## **Architectural Review Board Staff Report**

**Project Type:** Amended Architectural Elevations

**Description:** **Four Seasons Plaza West AAE:** Amended Architectural Elevations and Architect's Statement of Design for a 2.35 acre tract of land zoned "PC" Planned Commercial District located on the south side of Olive Boulevard, west of River Valley Drive.

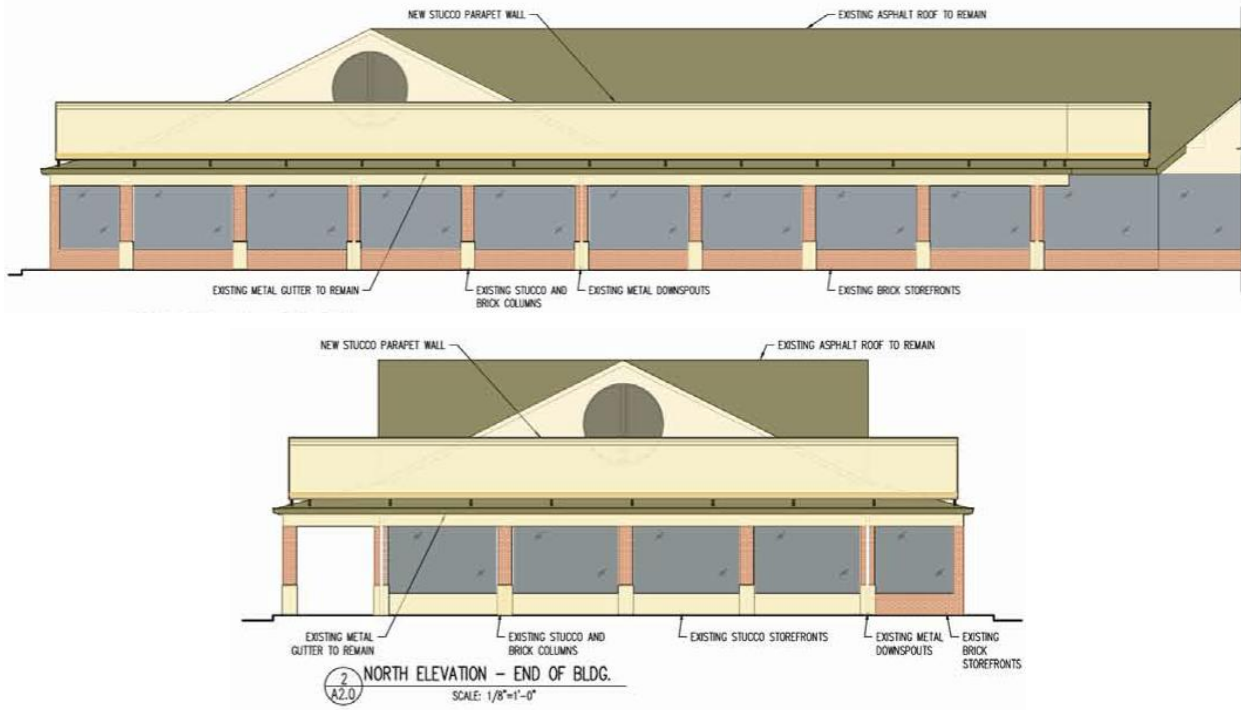
A comparison of the existing elevation and the proposed elevation can be seen in the images on the next page. An analysis of the proposal is given later in this section.

The proposed parapet wall will increase the vertical height of the flat façade of the existing structure. Although the building scale will appear slightly larger to pedestrians, the proposal is consistent with the height of adjacent structures in the Four Seasons Plaza development directly to the East.

Per the City's design standards, parapet walls should be treated as an integral part of the architecture and shall not visually weaken the design of the structure. The nature of this parapet wall as an addition on top of the existing hip and gable style roof does not allow for the integration into the existing architecture. The use of parapet walls is generally found with flat roof styles throughout the city including the adjacent developments. When used in conjunction with the hip and gable style roof, the parapet wall provides a slight interruption to the existing rhythm of the building's façade.

The proposed parapet wall will be composed of stucco on the exterior to match the existing gable materials and will also incorporate the same paint color that will be used on the existing stucco gables for the dominant color. A complementary accent color is proposed along the bottom edge of the stucco parapet wall to provide slight variation in the design.

Although the proposed changes are not fully integrated into the existing roof structure, the applicant has made efforts to use materials and colors that will provide some consistency with the existing structure. Staff requests action on the Amended Architectural Elevations and Architect’s Statement of Design for Four Seasons Plaza West.
